RENESAS TECHNICAL UPDATE

Product Category	System LSI		Document No.	TN-RIN-A005A/E	Rev.	1.00
Title	Hardware Real Time OS library issue (Mailbox queuing, timeout and wakeup request count)		Information Category	Technical Notification		
Applicable Product	See following	Lot No.	Reference Document	R-IN32M3 Series User's Manual R-IN32M3-CL (R18UZ0007EJ0202) R-IN32M3 Series User's Manual R-IN32M3-EC (R18UZ0003EJ0301) R-IN32M3 Series User's Manual Peripheral Functions R-IN32M3-CL R-IN32M3-EC (R18UZ0005EJ0601) R-IN32M3 Series Programming Manual (OS edition) R-IN32M3-EC R-IN32M3-CL (R18UZ0011EJ0400)		
		All lots

2.1. Issue 1 (Mailbox queuing)

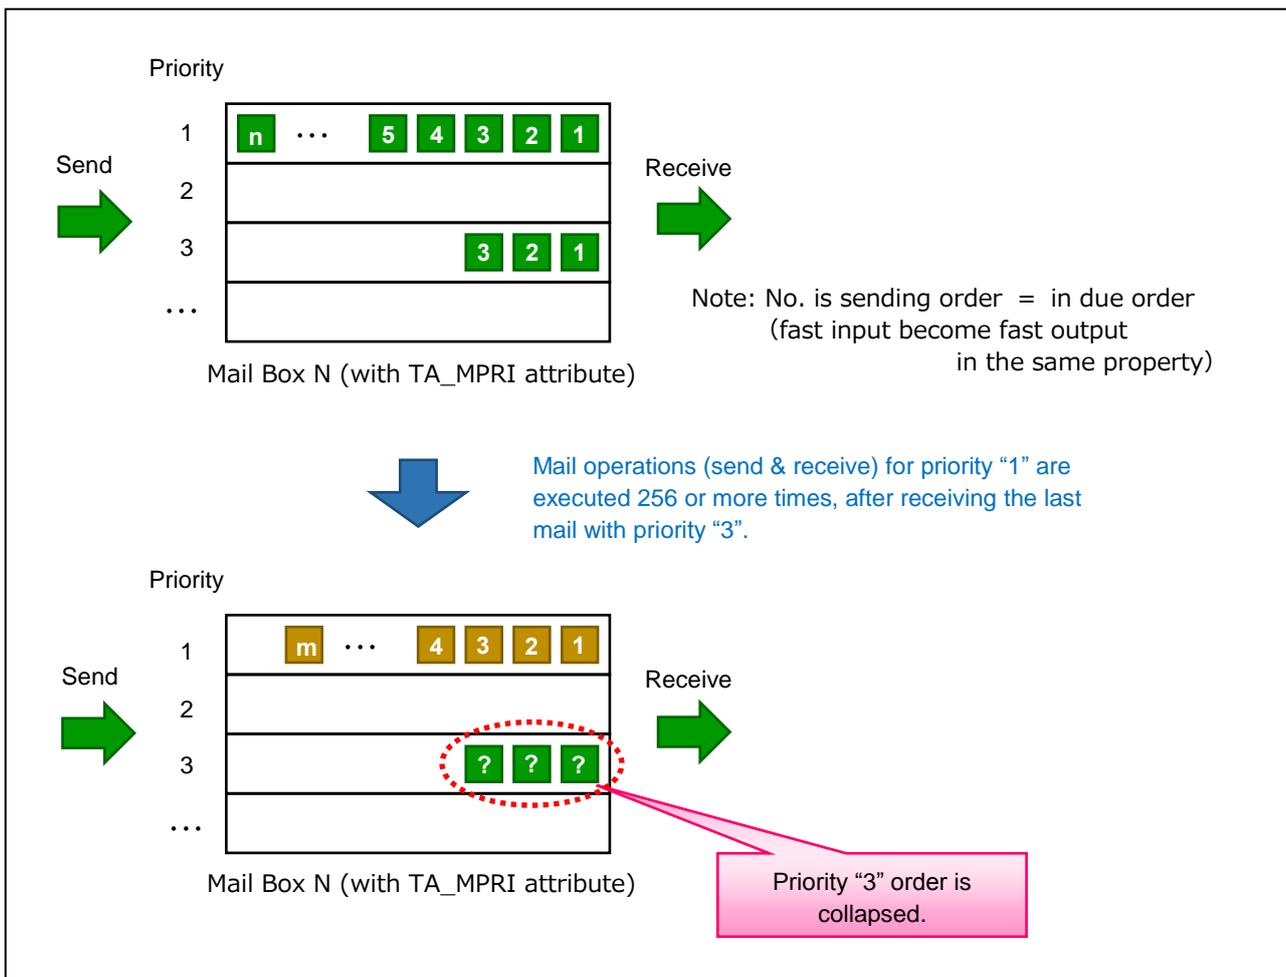
When using synchronization and communication function (mailbox) with TA_MPRI attribute that specifies queuing of messages in priority order, message queue ordering might not be kept in the same priority queue.

- Mailbox ID with TA_MPRI attribute is used.
- After multiple low priority messages are stored into the mailbox, high priority messages are sent and received 256 and more times without receiving the low priority messages.

- 1) Mailbox queuing
Basically, forbids to use mailbox with TA_MPRI attribute. (TA_MFIFO, message queue is in FIFO order, can be used.)
- 2) Timeout
Timeout action occurs 1ms earlier than specified time.
- 3) Wakeup request count
Forbids to issue “wup_tsk” and “iwup_tsk” system call when wakeup request count is the maximum (63).

- New service call supports enable/disable setting for mailbox with TA_MPRI attribute.
- Mailbox with TA_MPRI attribute is disabled as default.
- In the case of enabling mailbox with TA_MPRI attribute, specification of sending ASP is changed to return E_QOVR when one or more messages are left in the mailbox queue and sending APIs are issued 256 or more times. Same error will be returned until mailbox is empty. Thus, user has to receive the message until mailbox is empty.

2.2. Issue 2 (Timeout)

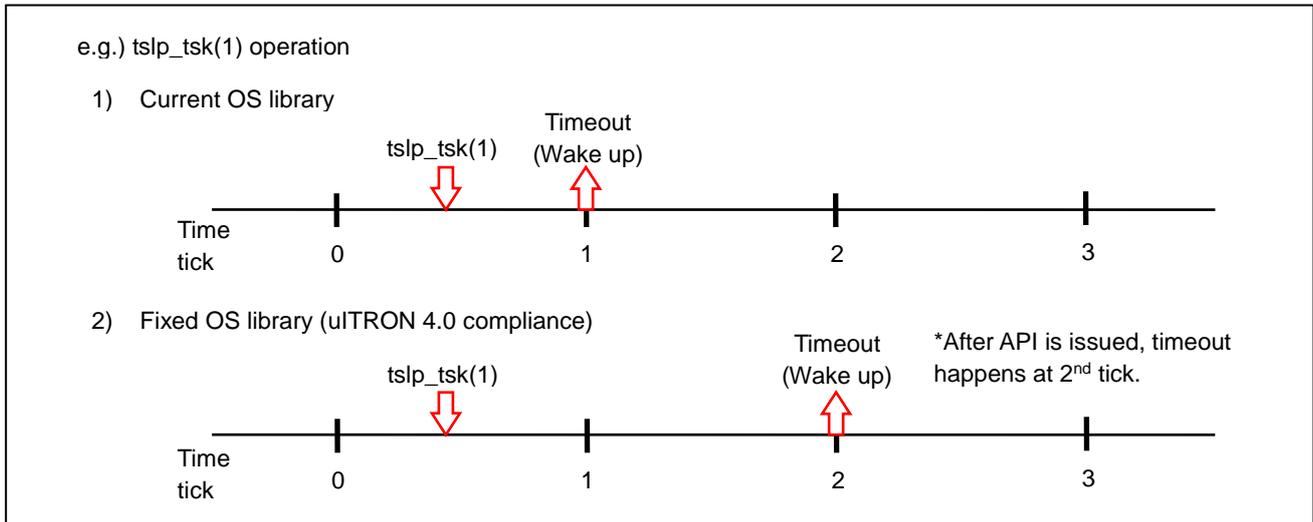
For service calls with timeout, Timeout action occurs 1ms earlier than specified time. When the following service calls are used and specified timeout is set to 1 or more, the issue will happen.

- tslp_tsk
- twai_sem
- twai_flg
- trcv_mbx
- tloc_mtx

The updated API follows uITRON 4.0 specification for Timeout.
